EL PASO COUNTY GRADING AND EROSION CONTROL PLAN

Buc-ee's #87

EPC STORMWATER REVIEW COMMENTS IN ORANGE BOXES WITH BLACK TEXT

GRADING AND EROSION CONTROL PLAN
EL PASO COUNTY

FINAL EROSION CONTROL PLAN - NORTH
GRADING AND EROSION CONTROL PLAN
EL PASO COUNTY
PREPARED FOR
BUC-EE'S, LTD.
COUNTY OF EL PASO COLORADO

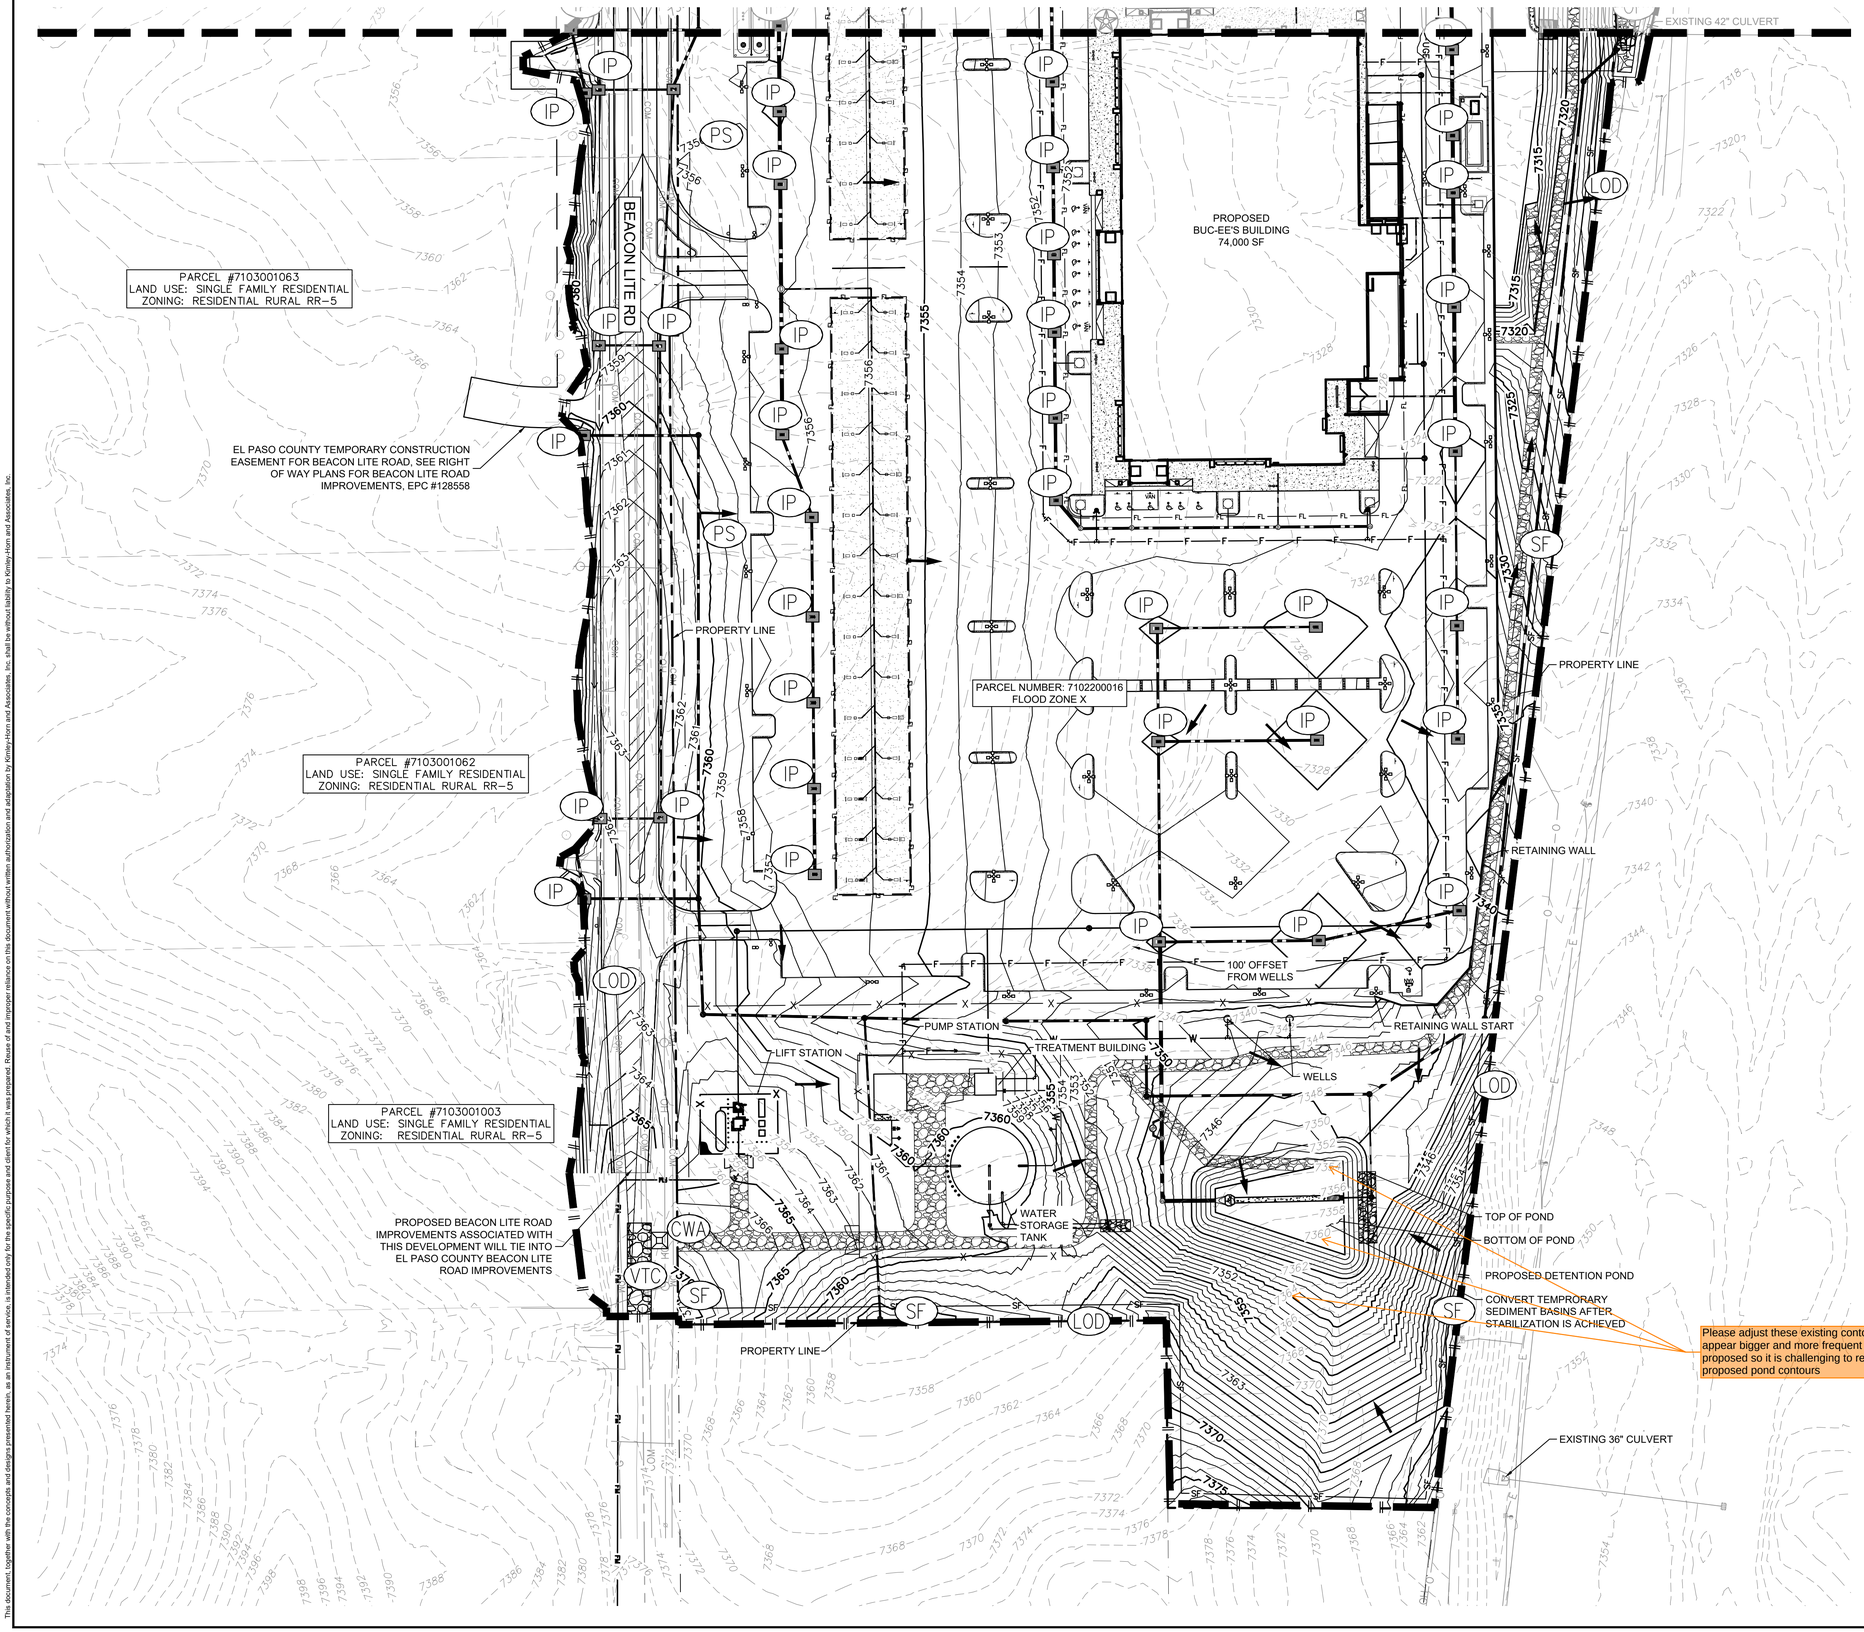
GEC Checklist Item Y - include all names of proposed PCMs. Typical comment for all three ponds.

GEC Checklist Item H - Show proposed pond easements and provide the record number if easements are to be recorded for ponds. The O&M Manual referenced specific easements so they must be shown on the plans or the O&M Manual will need to be updated. Typical comment for all ponds.

Sediment Basin (SB) SC-7

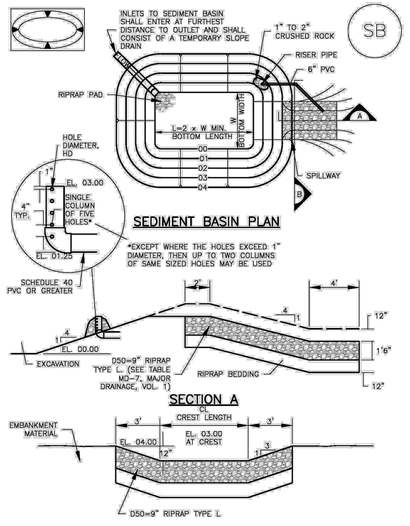
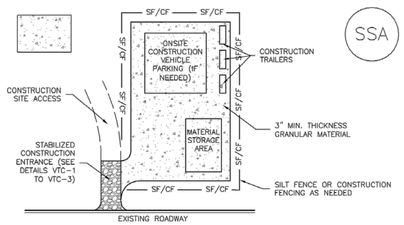
This total tributary area is not within the typical detail range and as such this TSB will require custom sizing. All dimensions and riser pipe details will need to be custom.

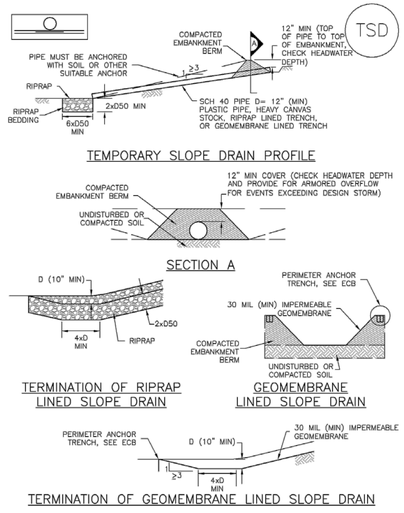
Neither table provides a specific temp or permanent seed mix. Provide full seed mix details

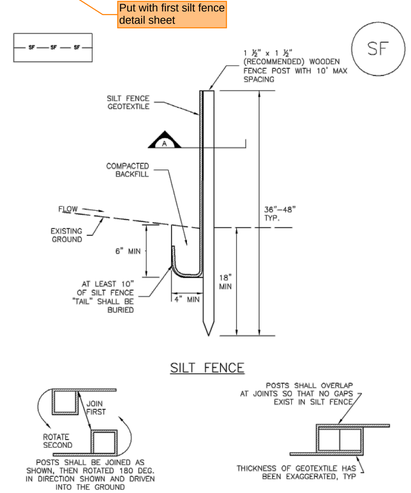
GEC Checklist Item X - Provide details for outfall protection and culvert inlet protection.

Put with first silt fence detail sheet
